Amendment No. 1

INTERCONNECTION AGREEMENT

January 3, 2017

**FIRST AMENDMENT TO
INTERCONNECTION AGREEMENT**

Exhibit "C3"
TSP Substation Location – TSP Interconnection Facilities

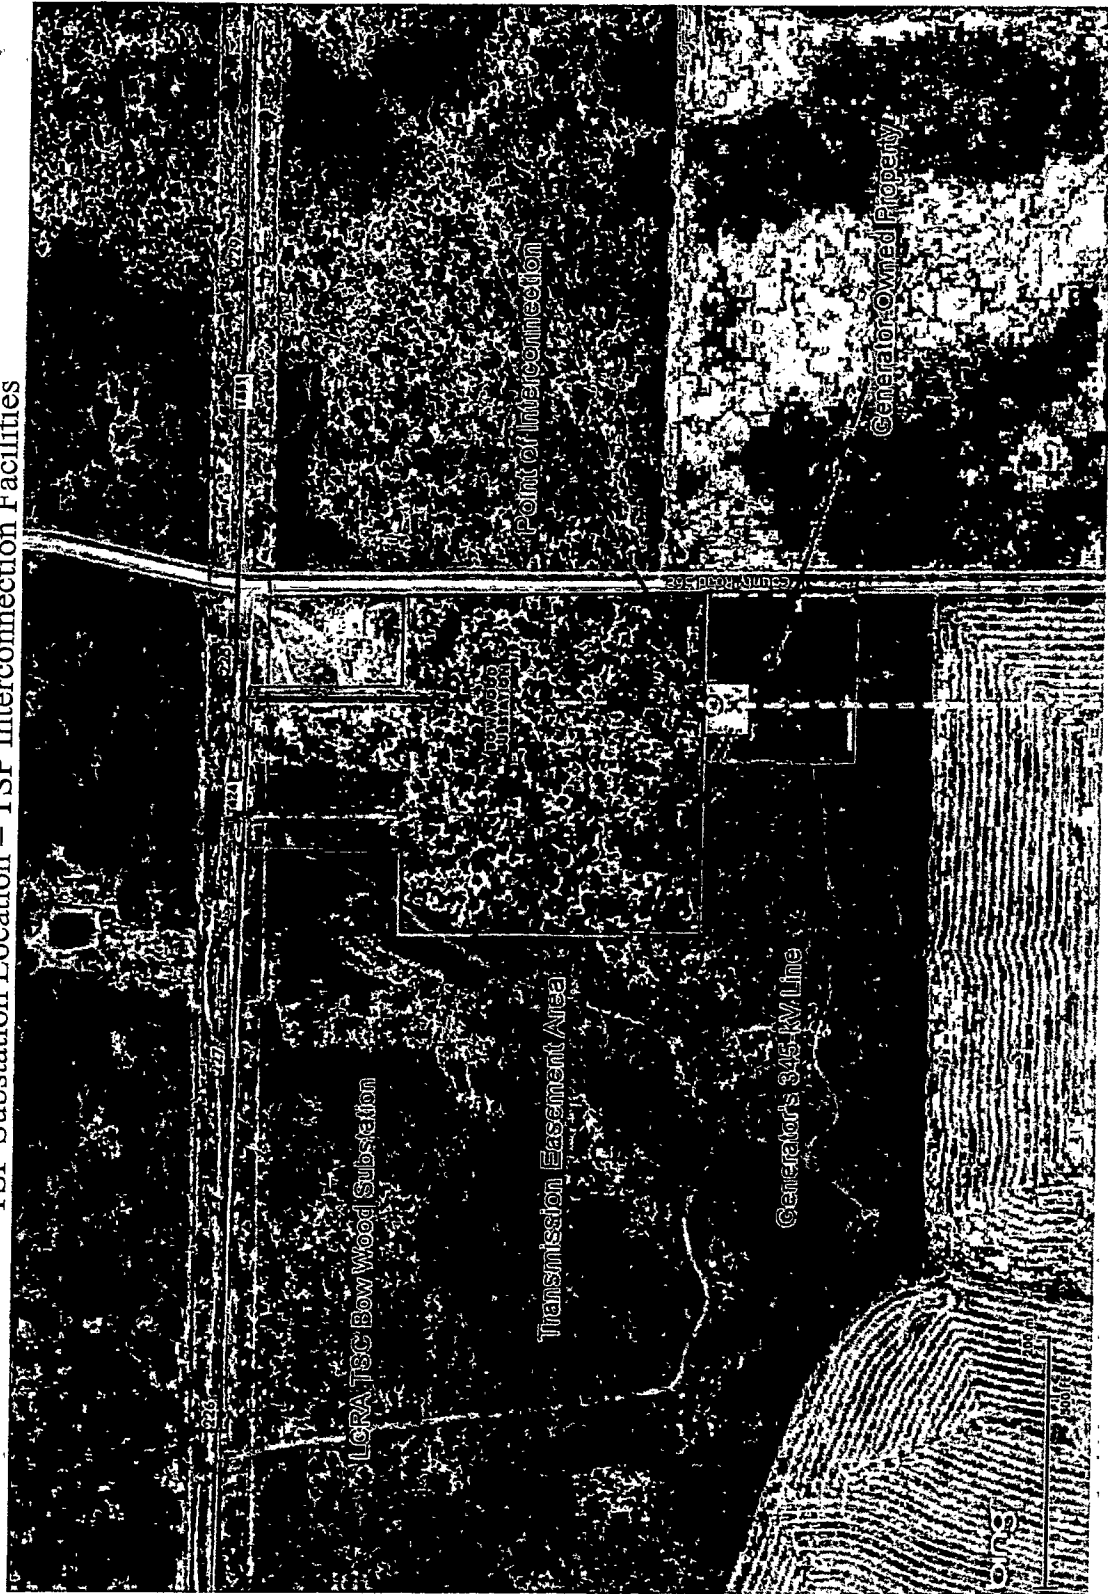
WHEREAS, the Generator and TSP agree to amend the boundary of the Substation Site to exclude this additional 2.4-acre parcel of land;

(b) In addition, TSP shall acquire easements providing good and adequate rights of vehicular ingress and egress to and from a public road and for access rights for necessary overhead and underground utility services and communication services to the Substation Site generally depicted in Exhibit "C3".

(c) Generator shall also, at no cost to TSP, acquire and convey to TSP, a separate stand-alone transmission easement, in a form approved by TSP, including access rights for the portion of the TIF previously described in item 8. D) above and as generally depicted as the "Transmission Easement Area" in Exhibit "C3".
